RE: Lincoln Drive Median Access from Mockingbird Lane to the Eastern Town Limits

MEMORANDUM

Subject: Lincoln Drive, Mockingbird Lane to Town of Paradise Valley (TOPV) Jurisdiction
Median Breaks and Access
Third Party Traffic Review Comments

Resort Hotel (330)

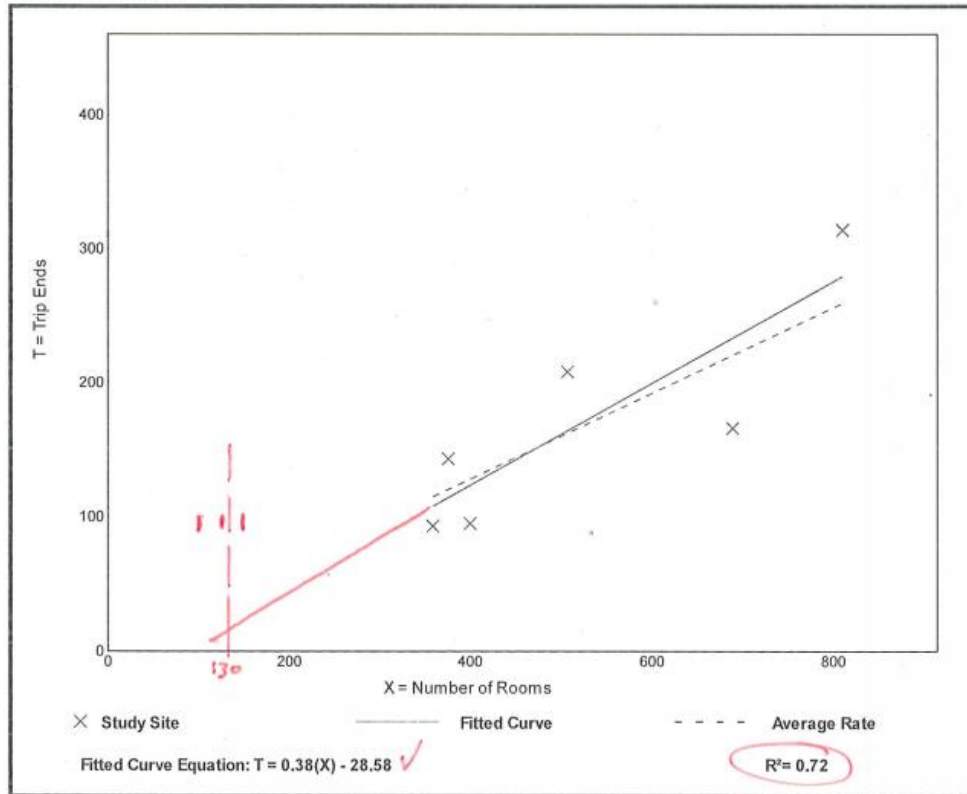
KH Comments 4: Smoke Tree Resort utilized equations as opposed to average rates. KHA went through the ITE Trip Generation Handbook process presented in Figure 4.2 assuming proposed number of units for resort hotel (LUC 330). The results of this process are presented below and KH redlines provided in **Appendix 1**.

- The number of rooms is way out of range of the data extremes; the lowest number of rooms in the manual is roughly 370 compared to the 132 that are proposed
- If you follow the equation, which happens to be a straight line and not a logarithmic function, then 132 rooms will generate a very low number of trips
- The number of data points is equal to 6
- The R2 value is close to the required 0.75, so you could argue it either way
- The standard deviation is less than 55% of the average rate

Because the rooms are not within the data extremes and the R2 value is less than 0.75, we recommend the weighted rates be used. Using the rates as opposed to the equation results in double the trips being generated in the AM peak hour.

Response to Comment 4: CivTech has updated the trip generation rates to reflect a blended rate between LUC 310 and 330 as discussed in response to comment #3. The trip generation calculations were also revised to reflect 150 rooms, 30 residential units, and 3500 square foot quality restaurant. The revised trip generation calculations and approach were considered acceptable. The revised trip generation calculations, based on 150 rooms, 30 residential units, and 3500 square foot quality restaurant, are provided in **Appendix 2**.

Resort Hotel (330)

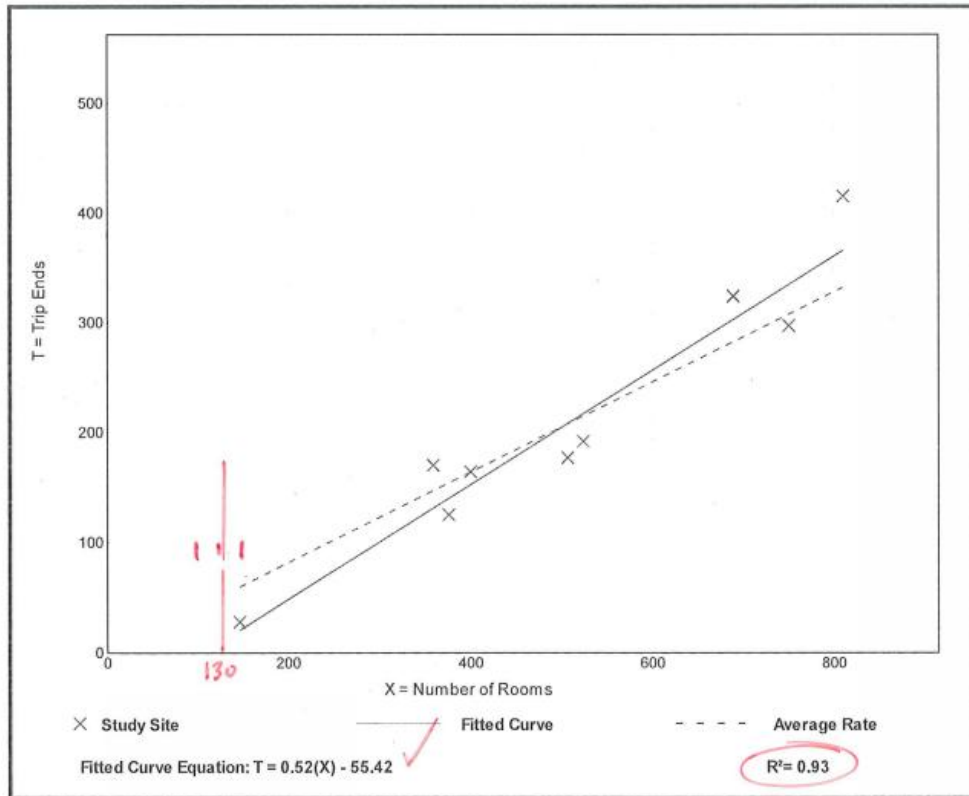
- The number of rooms is just outside of the data extremes
- The number of data points is greater than 6
- The R2 value is well above the required 0.75
- The standard deviation is less than 55% of the average rate

Because the number of data points and the R2 value are high enough and the standard deviation requirement is met, the use of the equation during the PM peak is appropriate.

SHEET
 Opt-01
 01 OF 03

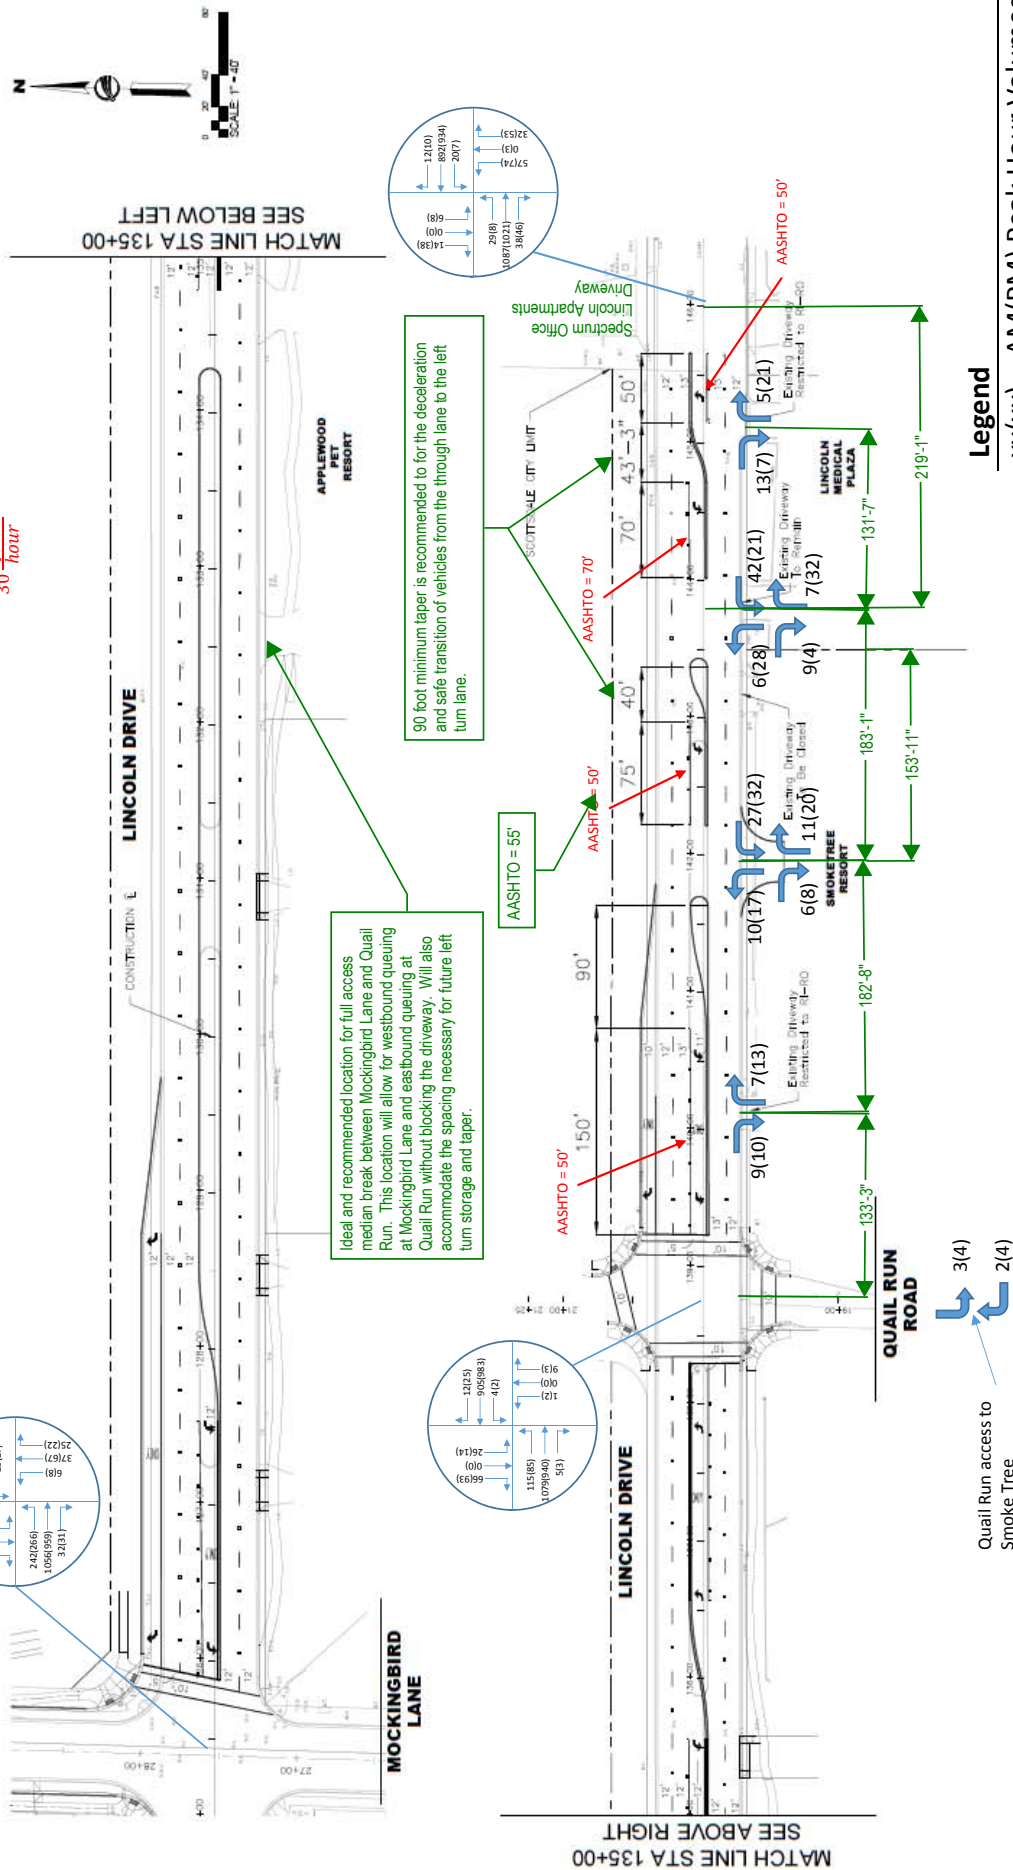
KH Comment 10: Storage length at Spectrum Office Driveway/AJ Driveway calculation ((29 vph x 25 feet x 2)/30) is 48 feet. Per AASHTO, the minimum storage length is 50 feet. Exhibit illustrates a minimum of 50 foot being provided. This is considered acceptable.

KH Comment 11: As shown in Option #1 exhibit, access improvements include closure of the existing eastern access on Smoke Tree Resort, a new Smoke Tree Resort access approximately 183 feet west of Lincoln Medical Plaza access, and the existing Smoke Tree Resort western access to remain as right in/right out. The proposed improvements result in the following spacing (centerline to centerline) of driveways:

Based on the results, Kimley-Horn recommends the western Smoke Tree Resort driveway be closed to achieve the minimum spacing from Quail Run.

KH Comment 12: The storage length shown in Option #1 exhibit for Lincoln Medical Plaza is 70 feet. Per AASHTO calculations, storage length should be no less than 70 feet to adequately store the estimated number of vehicles generated by Lincoln Medical Plaza. This is considered acceptable. The storage length for the Smoke Tree Resort eastern driveway is 75 feet. Per AASHTO calculations, storage length should be no less than 55 feet to adequately store the estimated number of vehicles generated by the Smoke Tree Resort. This is considered acceptable.

KH Comment 13: As shown in Option 1 exhibit prepared by CivTech, opening bay tapers are 40 feet at Smoke Tree Resort and 43-3” feet at Lincoln Medical Plaza. KH recommends that no less than a 90-foot opening taper be utilized to safely traverse traffic from the through lane to the left turn lane on Lincoln Drive, per the criteria and discussion on Page 4, 5, and 6 of this document. Kimley-Horn recommends the median be extended and access points to Lincoln Medical Plaza be restricted to right in/right out only movements for two reasons:
